Millstone Nuclear Power Station, Unit No. 3
NRC-Chemical Engineering Branch (CMEB) (Fire Protection)
Review Meeting, May 10, 1984

FP-19 Cable Spreading Room Protection

FP-19, Cable Spreading Room Protection (Draft SER Section 9.5.1.6)

CO₂ ARRANGEMENT CABLE SPREADING ROOM

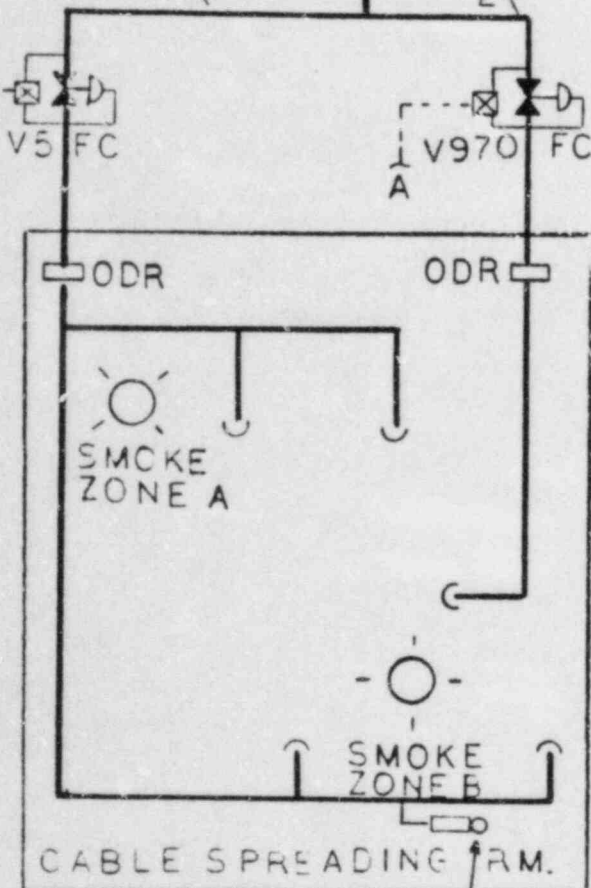
The primary fire suppression in the cable spreading room is a total flooding automatic carbon dioxide system. We will require the applicant to provide an automatic fixed water suppression system as the primary fire suppression means in the cable spreading room with the carbon dioxide system as a backup to meet the guidelines of BTP CMEB 9.5-1, Section C.7.c. This is an open item.

Distribution piping/valving has been arranged to allow CO₂ discharge directly into the affected area (refer to Sketch #1). Predetermined time discharges provide the proper amount of CO₂ to enter the area as required to satisfy NFPA 12 guidelines/design concentrations.
